Dam Safety Assessment of CCW Impoundments

Joppa Plant

United States Environmental Protection Agency
Washington, DC

September 24, 2010

PHOTO LOCATIONS
AND SITE FEATURES

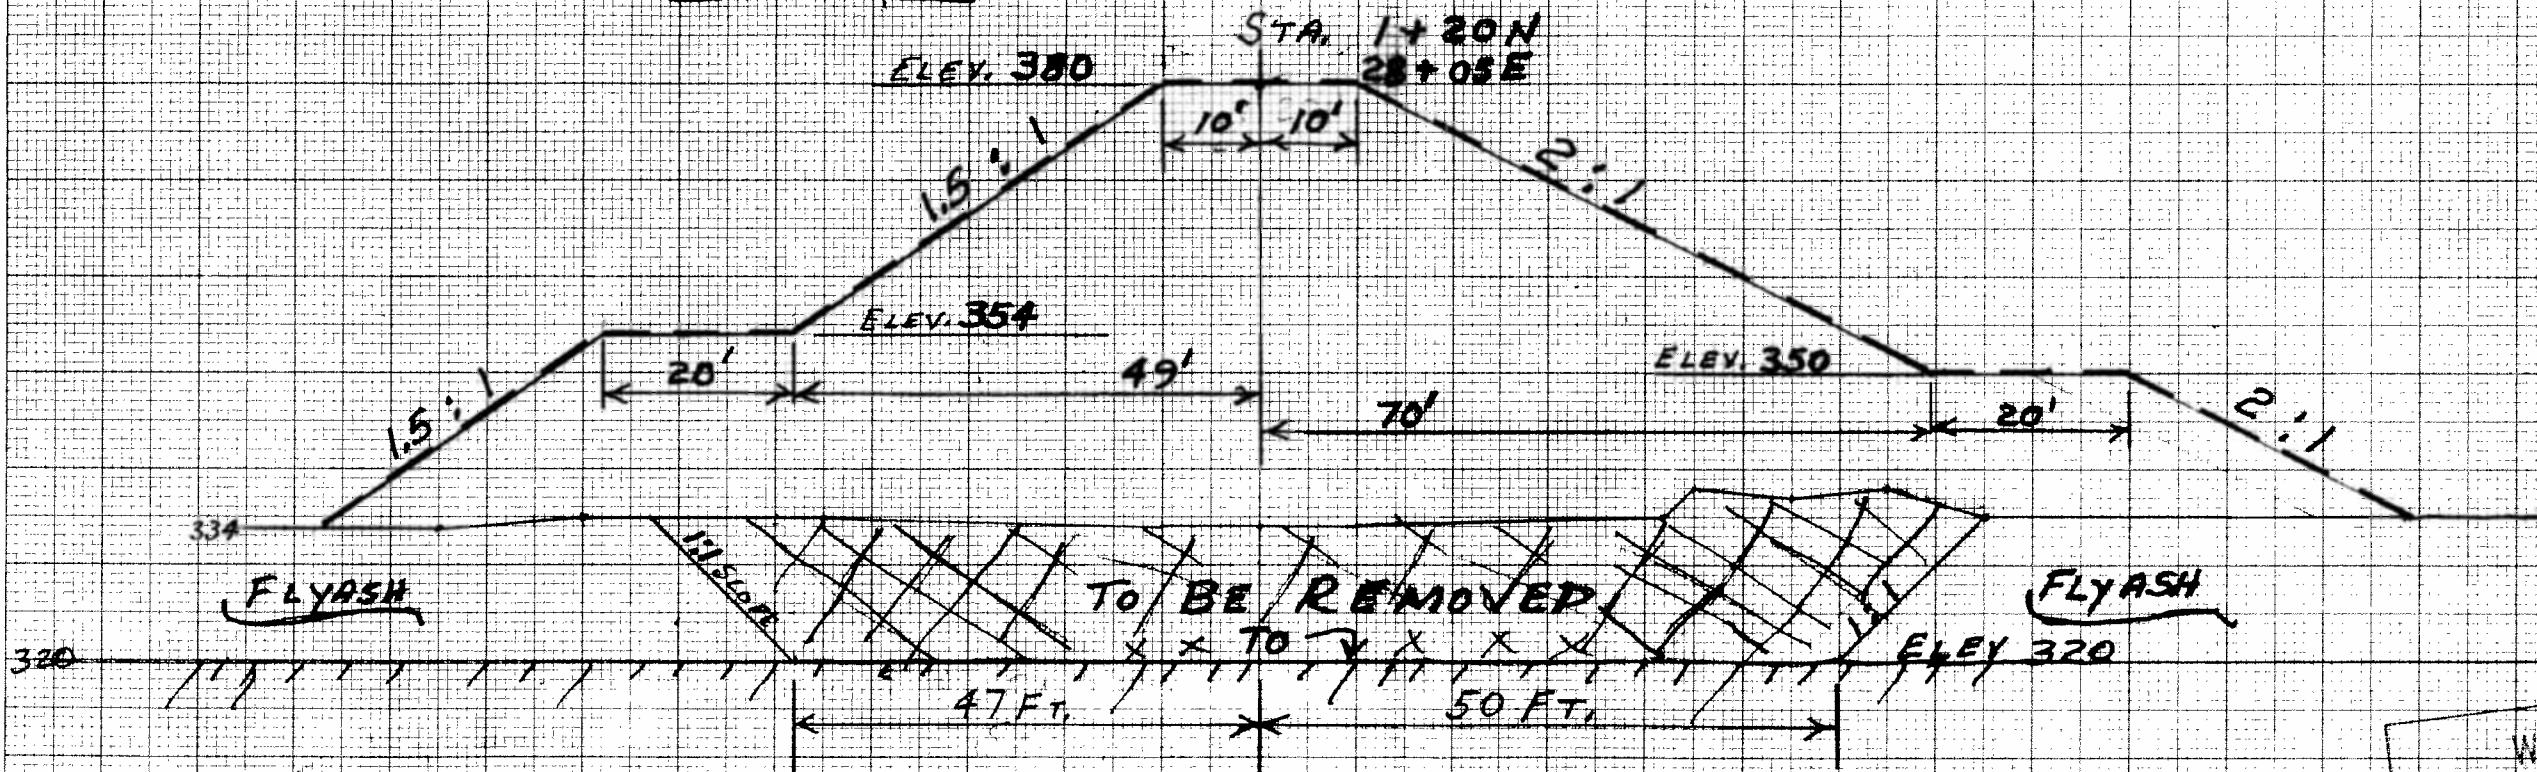
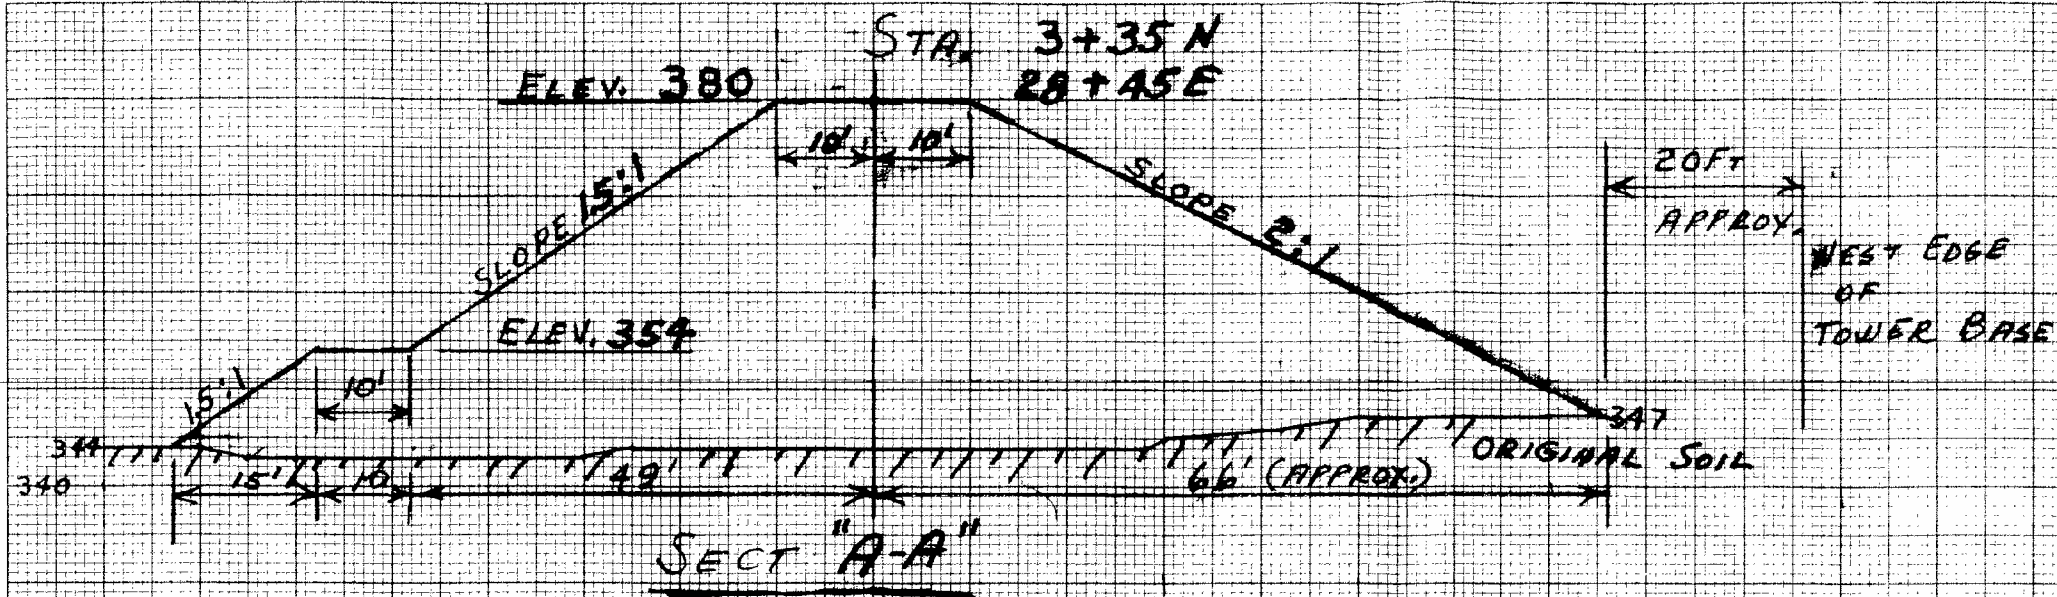
- Seepage was observed in multiple locations along the outboard toe of the embankment. The most significant area of seepage is located approximately 500 feet north of the power lines (Photos 23 & 24). Other areas where seepage was observed include an area approximately 200 feet south of the power lines and along the southern embankment of the Southern Pond. The approximate locations of seepage are identified on Figure 3.

AP-109 SH. 1

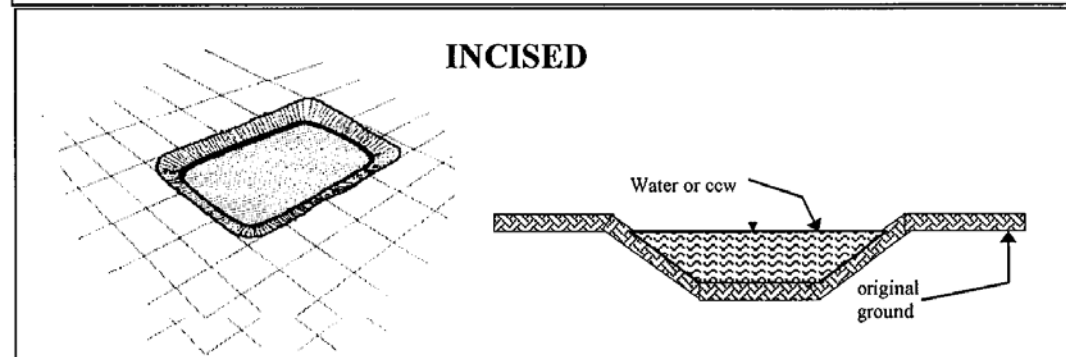
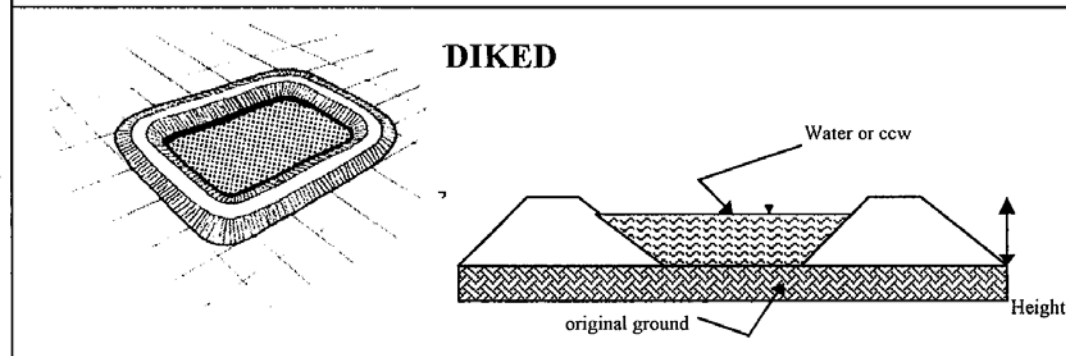
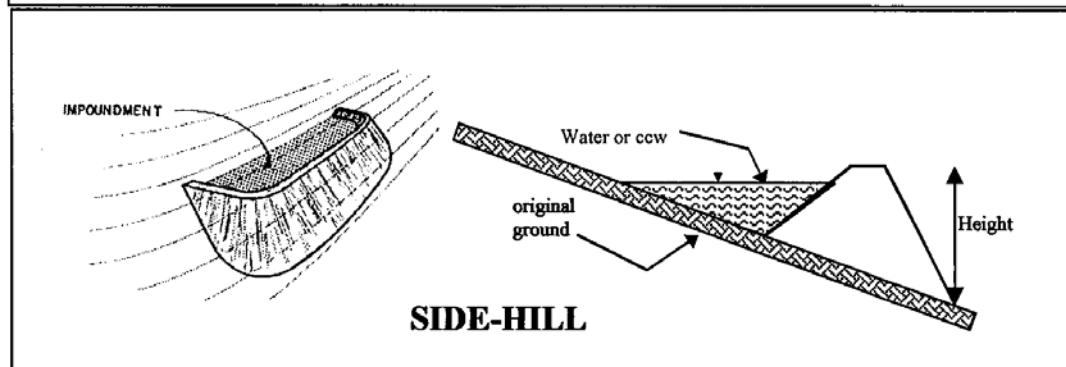
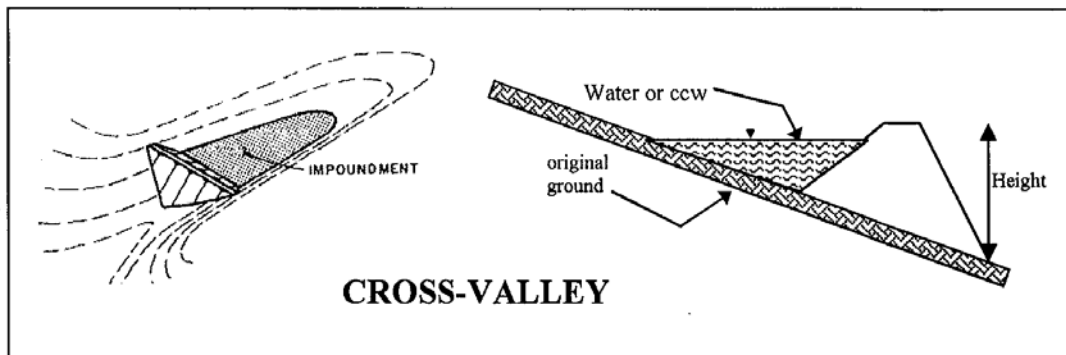
- The outboard slope is steeper than generally recommended for dam and dike construction. The design drawings (See attached EEI Drawing AP-109) indicate the slope should be 2H:1V, but the observed slope appeared to be steeper and matched the 1.5H:1V slope of the Northern Pond.

- Based on Drawing AP-109, Sht. 1 (attached), the Southern Pond embankment was keyed into a suitable foundation through a layer of fly ash for a portion of the embankment. Section A-A, which is indicative of construction in the area near the power lines (Dwg. 4229-8211, Sht. 1), indicates that this section of the embankment was not keyed into the underlying foundation.
